Report: HMC-C200 stability problems

1. Background

Screws not properly fastened when received - SN 1541-0002 on the left, SN 1541-0001 centre and right

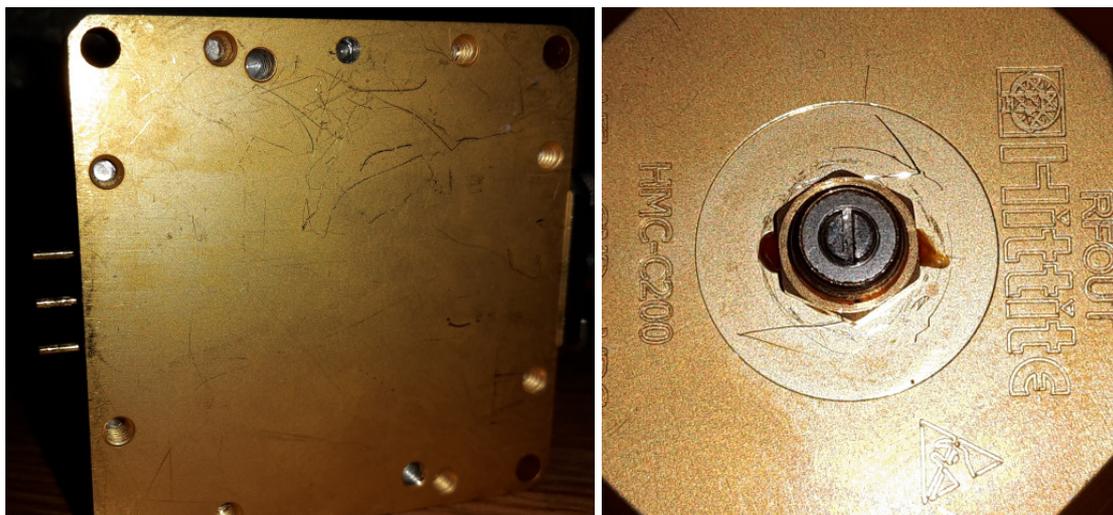
It was observed that, when received, some of the screws on the two 8.1 GHz modules were not fully fastened. The modules also showed some scratch marks.

The modules were initially tested without adjusting the screws, but later they were fastened. It did not make a difference to the results.

Output power spectrum showing close-in spurs

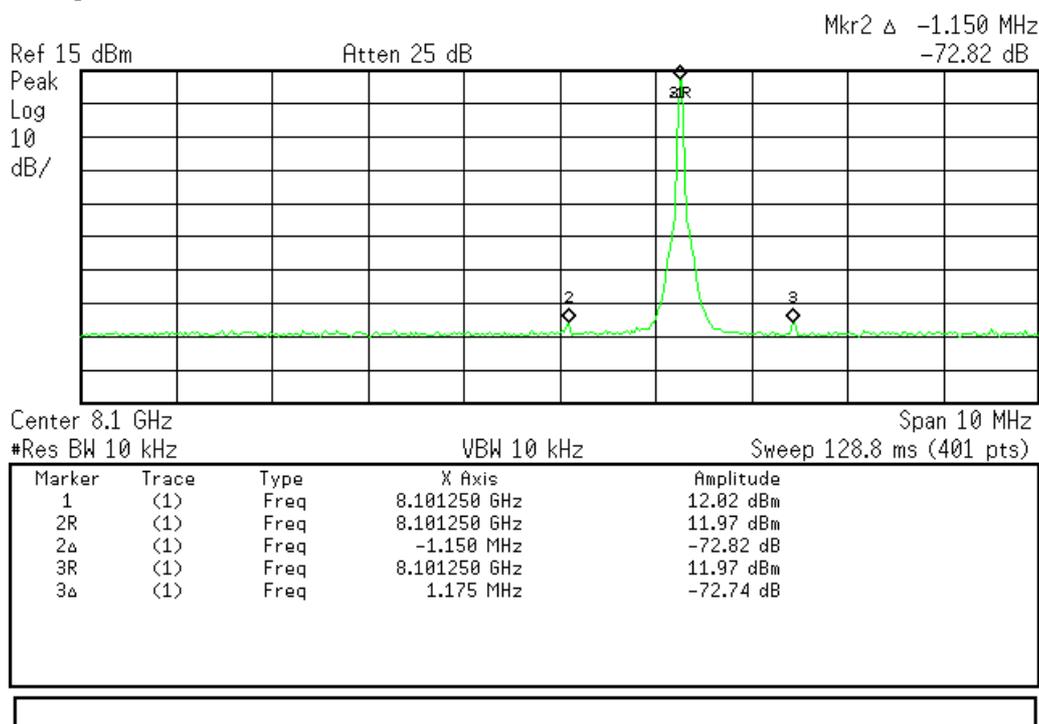
The 8.1 GHz unit was measured on the spectrum analyser and it was found that the max output power was achieved with a VT of 6.5V. Some spurs were observed close to the carrier (see figure below). Harmonics were measured to be -24.9 dBm (higher than specified) and -35.0 dBm for second and third harmonics respectively. The power meter confirmed the output power level to be 13.5 dBm.

Measured phase noise of 8.1 GHz module (SN 1541-0002), with 100nF decoupling capacitor on VT pin, VDC = 6.4V, VT = 6.5V. A hand is moving close to the DC pins, causing a disturbance.

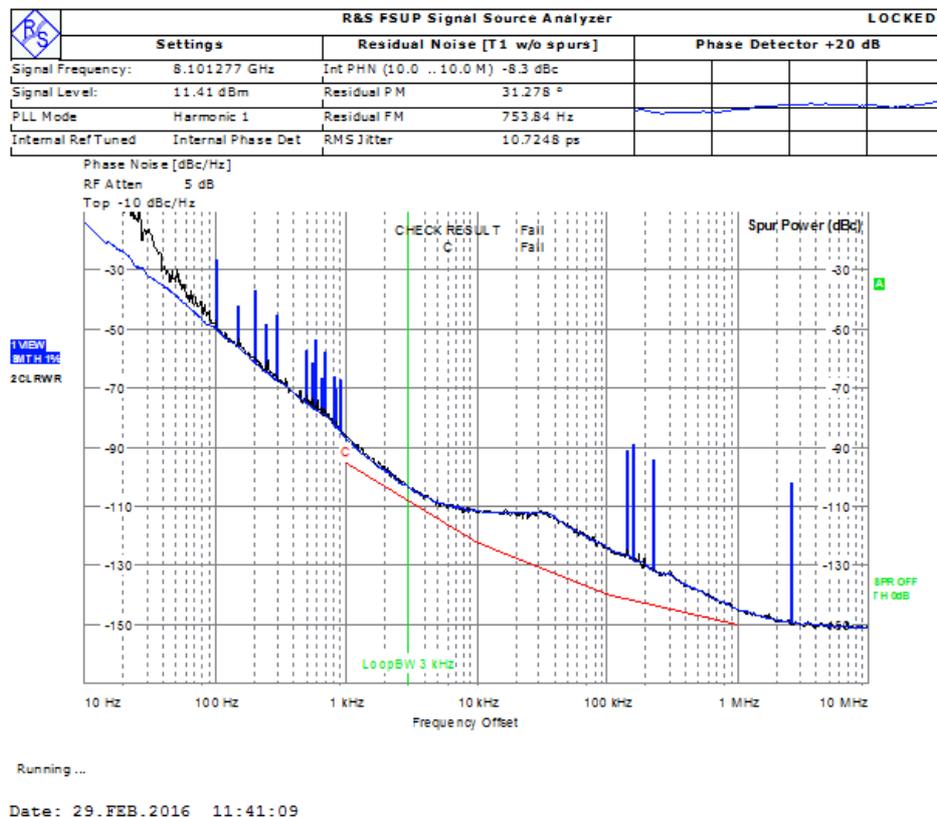
The test setup was extremely sensitive to any disturbance or movement. It was easily demonstrated that touching the RF cable between the DRO and signal analyser caused a disturbance in the output signal. Touching the DRO casing caused a shift in frequency. Waving one's hand close to the DC pins caused disturbances in the phase noise. These responses are hard to quantify or capture in a photo, but they were *not* subtle. In the screen shot below, a disturbance can be seen in the low-frequency phase noise (black trace) and the detector trace (top right of the image). This disturbance was caused by waving a hand close to the unit, and is *very small* compared to other disturbances witnessed.

Is it possible that there is RF leakage present outside the unit, which couples back into the module and which can be easily disturbed in the ways described above?

RF pin on DRO module, with SMA connector removed

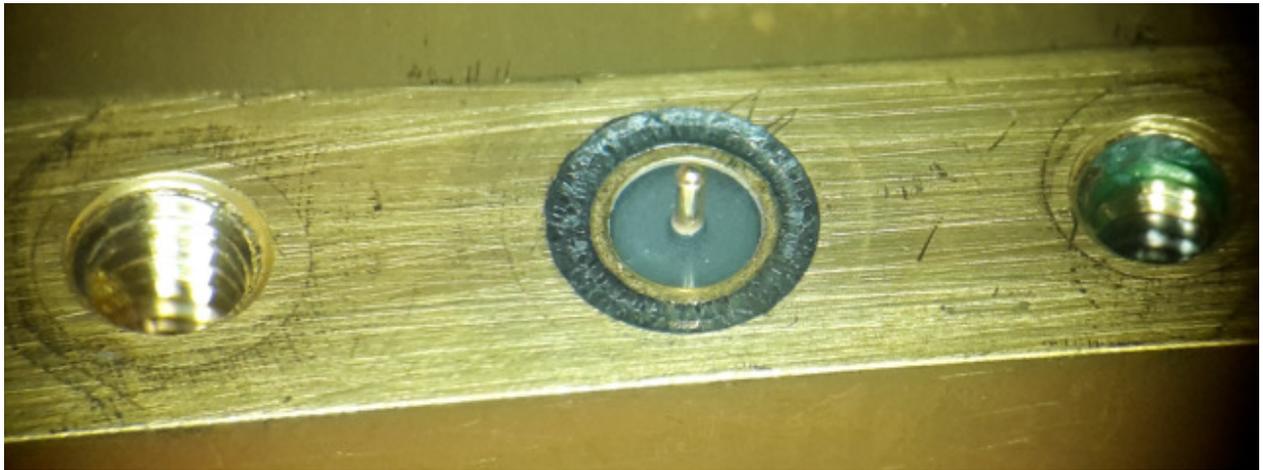
The field-replaceable SMA connector of one of the modules was removed. It was observed that the ground ring of the coaxial transition is not positioned flush with the surface of the module (see picture below). Instead, it is slightly recessed. This will cause an air gap between the ground surface of the field-replaceable SMA connector and the ground ring on the DRO module, when they are mated. This is a cause of concern and possibly the reason that the RF signal is leaking out of the module.

Experiments using shim to provide a more continuous ground ring did lead to an improvement in the sensitivity.

It is also unusual that the GND pin is not grounded directly on the chassis where the pin enters the body, but instead leads to a feedthrough component. Does this not create a path for disturbances on the line to enter the cavity?
